SUBJECT: Review and Discuss 2018/19 Environmental Commission Targets and Work Plan

SUBJECT: Street Shoulder Improvement Policy

Subject: Shoulder Paving Policy

Date: November 2, 2016
To: Susanna Chan, PE
From: Marcy Kamerath, CPSWQ, QSD/QSP, Franz Haidinger, PE
Subject: Los Altos Shoulder Paving Policy (Standard Detail SU-20, May 2010)

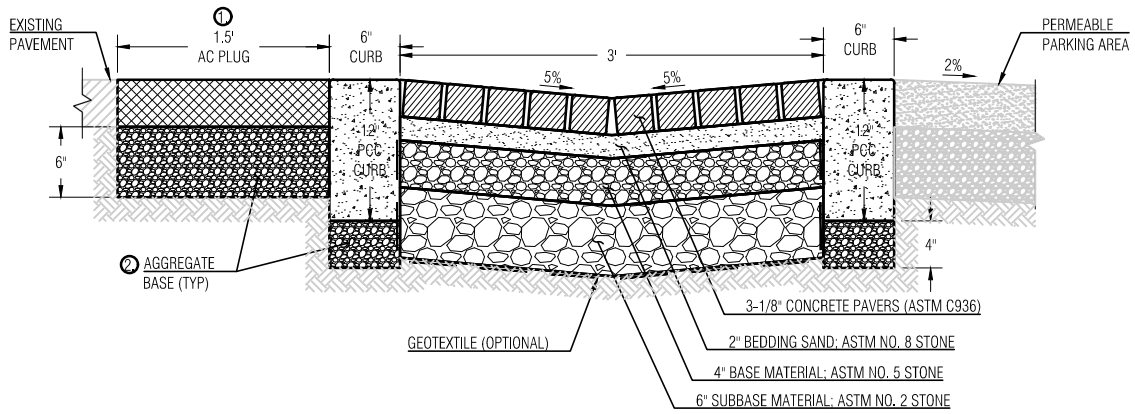
In response to public feedback, staff revisited the Policy Detail to look for opportunities to address their comments. One of the concerns of using permeable materials in the shoulder area is the potential of moisture getting underneath the pavement and overtime weakening the ability of the base rock to support the street. One option to address this concern is to install

a small concrete water barrier between the pavement edge and the shoulder area. The water barrier will be leveled with the street surface so it does not post a tripping hazard. The installation of this water barrier opens up the possibilities of using permeable materials in the shoulder area. Staff has directed the consultant to develop permeable swale options for consideration, including:

- Compacted Aggregate Base
- HDPE Paver
- Cellular Concrete Blocks
- Permeable Concrete Pavers

The details of these options are included in Attachment 3. The costs associated with these options are currently being developed by the consultant and will be available at the Commission meeting.

Figure 3 - Recommended revisions to the Policy

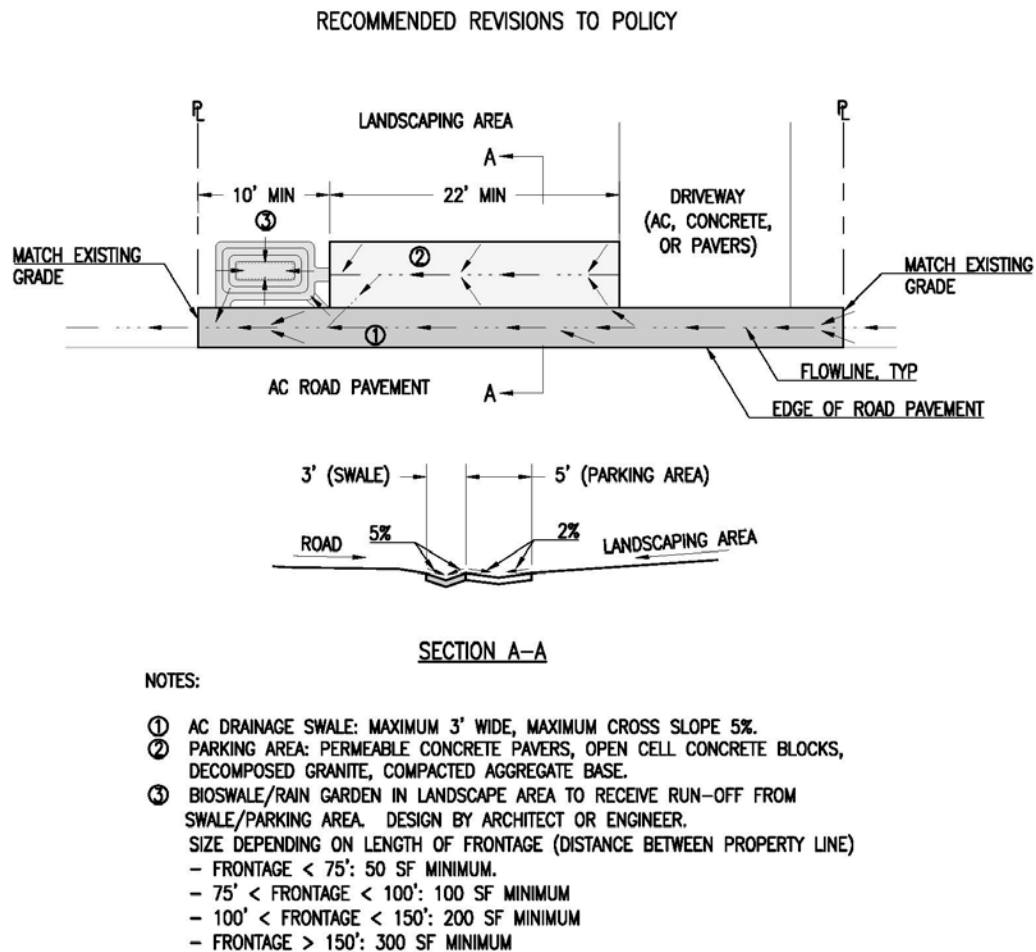
Clarifications which could improve the Policy are included in **Figure 3** and include the following:

- Flow routing – Flow paths are presented in Figure 3 to provide clarification and guide contractors implementing the shoulder improvements. Constructing improvements consistent with the illustrated flow paths will promote positive drainage through the swale, allow the shoulder parking area to receive and capture some runoff, and route excess flows to the drainage swale.

- Match existing grades – To reduce drainage issues associated with planned improvements, the Policy should specify that the up and downstream limit of improvements must match existing grade.
